Campaign Update CA#9277

Subject: Equalizer Leveling System
Affects certain 2019 Unity Motorhomes

SOP01956
GAAR 9277 Tighten Front
Leveling Jack BoxBolt

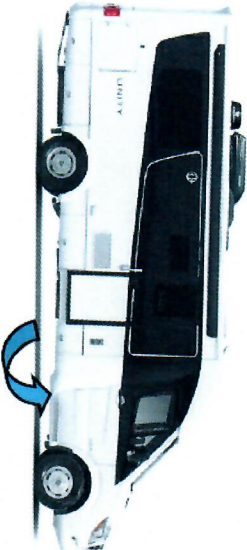
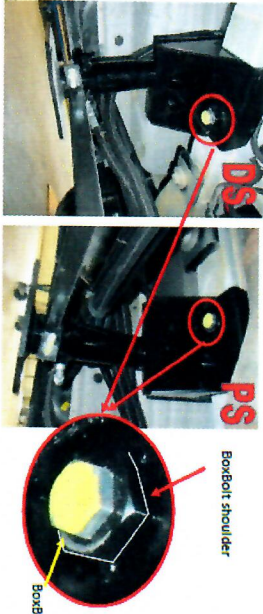
The Equalizer leveling system front jack mounts have an expansion fit BoxBolt that requires it to be torqued to 140 ft. lbs.

1 Locate the front leveling jacks under the coach just rear of the cab doors.	 2 BoxBolt shoulder Locate the BoxBolt expansion bolt. BoxBolt head.
 3 Set torque wrench set to 140ft.lbs. with a 15/16" socket.	 4 Hold the hexagon shoulder of the BoxBolt with a open ended wrench. Place the socket on the BoxBolt head.
 5 Tighten bolt clockwise until the torque wrench feature activates. (usually a click)	6 Repeat for the other side.
